## GFAC update for the IGC Plenary Agenda

dated 8 February 2022

## IGC Flight Recorders – To Calibrate or Not to Calibrate

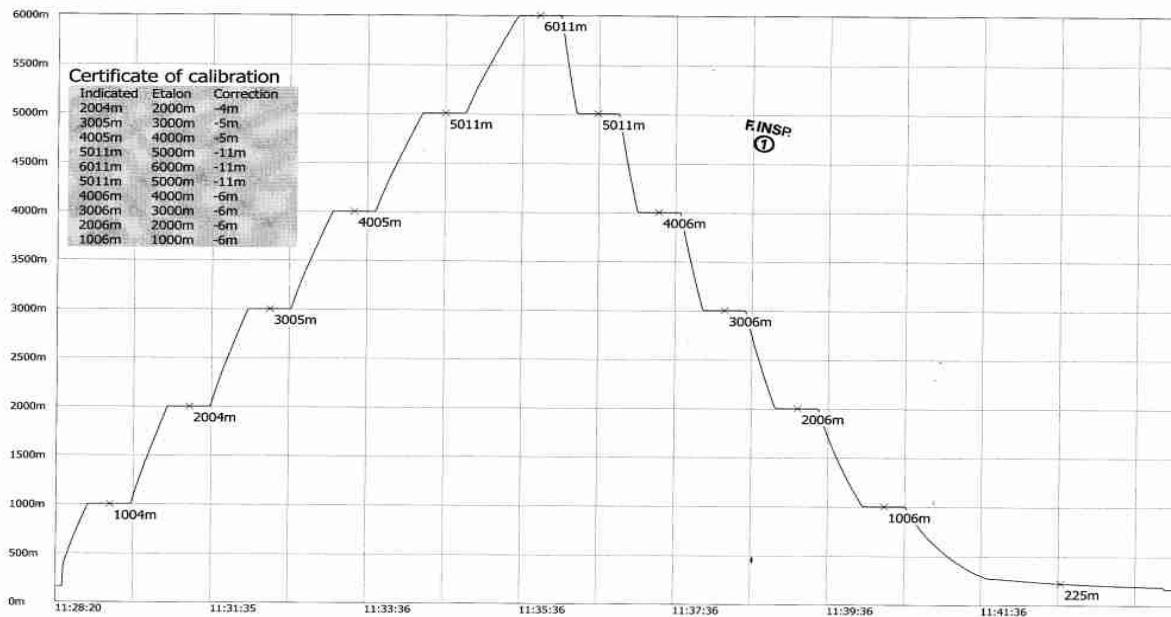
I have calibrated around 150 LXNAV and LX Navigation FRs and these show about a 3% failure rate. Since world sales are estimated to be at least 10 times this figure, expanding to all units indicates that there may be quite a few out there with calibrations outside IGC specification limits. For example, 30 LX Navigation LX7007 units were calibrated between 2019 and 2021 and 10% of those tested (all in 2021) had errors that are listed below.

FR Serial 9J2 18 Nov 21	FR Q8U 28 Mar 21	FR QJA 23 Jun 21
+27m @ 0 ft	+19m @ 0 ft	+11m @ 0 ft
+41m @ 10k ft	+30m @ 10k ft	+18m @ 10k ft
+69m @ 20k ft	+53m @ 20k ft	+38m @ 20k ft
+85m @ 30k ft	+75m @ 30k ft	+55m @ 30k ft

Since these FRs will have been calibrated on leaving the factory and adjusted to reduce the errors, the above figures show that reliance on an initial manufacturer's calibration with no periodic re-calibration, is not acceptable.
